# UNITED STATES PATENT AND TRADEMARK OFFICE

APPLICATION NO.	FILING DATE	FIRST NAMED INVENTOR	ATTORNEY DOCKET NO.	CONFIRMATION NO.
10/024,570	12/21/2001	Herbert Jainek	178/50786	2454

<b>Office Action Summary</b>	<b>Application No.</b> 10/024,570	<b>Applicant(s)</b> JAINEK, HERBERT	
	<b>Examiner</b> Mr. Terry K. Cecil	<b>Art Unit</b> 1723

## DETAILED ACTION

As shown by the arrows in figure 2 reproduced below, fluid to be filtered enters channel 6 and then flows radially outward and into the pre-filt chamber 7 that extends between the filter element and the chamber.

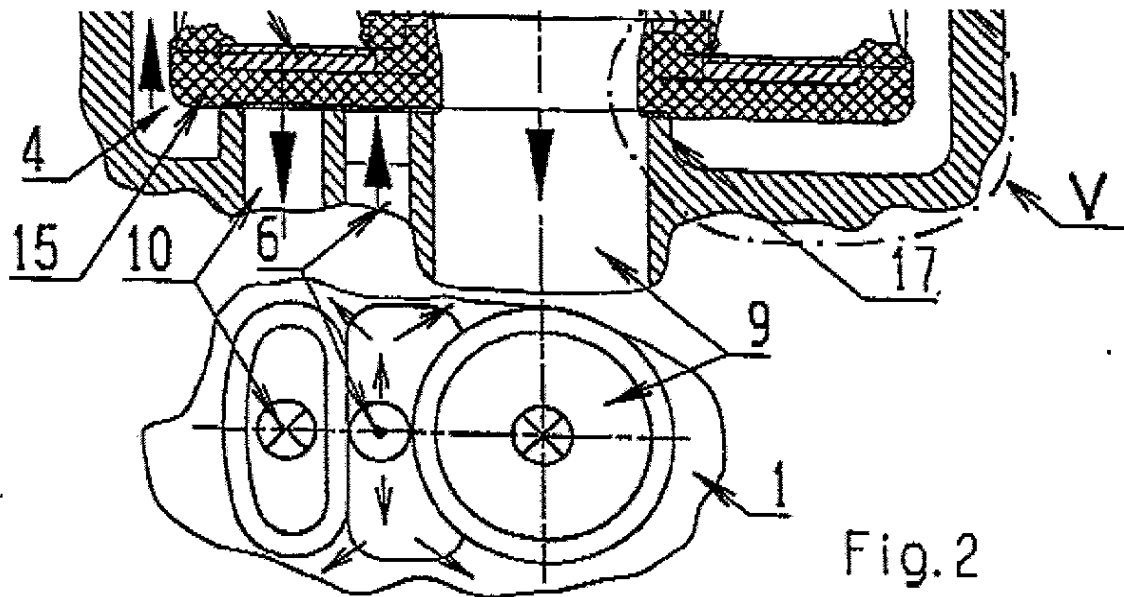
5. Claims 2-9 are rejected under 35 U.S.C. 103(a) as being unpatentable over the European reference (EP-1,031,367-A1), hereinafter “‘367” in view of Gandini et al. (U.S. 6,485,635 B1), hereinafter “Gandini”. As shown in figure 4, the axially installed filter seals a return drain channel 10 upon installation. Member 15 is provided on the disc 4 to create a first seal in front of the channel 10 and a second seal against the filtered flow outlet pipe 9. The arrangement is configured such that upon axial withdraw of the filter the first seal is unseated followed by the second seal [as in claim 9] because the second seal has a longer range of motion [as in claim 2]. Notice that the first seal seats against an axial projection of the housing that defines the return channel [as in claim 3] part of which lies between the inlet 6 and the drain return channel [as in claim 4]. The seal 15 also extends radially to form the second seal [as in claim 5]. The filter is configured for filtering engine fluids [as in claim 8].

However, '367 does not teach the first seal assembly to be disposed in front of the inlet (downstream of) to reduce back flow of unfiltered liquid from the unfiltered side of the filter element to the inlet and of the filter arrangement during operation. Gandini teaches such a seal that includes an antidrainback member 28 [as in claim 9] that extends radially outward from the radial edge of the filter element [as in claim 6] and rests against the housing (this part of the housing can be considered a "stop" [as in claim 7]. It is considered that it would have been obvious to one ordinarily skilled in the art at the time of the invention to have the member 28 of Gandini to extend from the disc element 4 to the housing in the area of the arrows of figure 2, since Gandini teaches the benefit of preventing the filter from running empty (col. 2, lines 7-8).

This would prevent the filter from draining after the engine is shut off in order to avoid a lag time for filtered fluid when the engine is restarted.
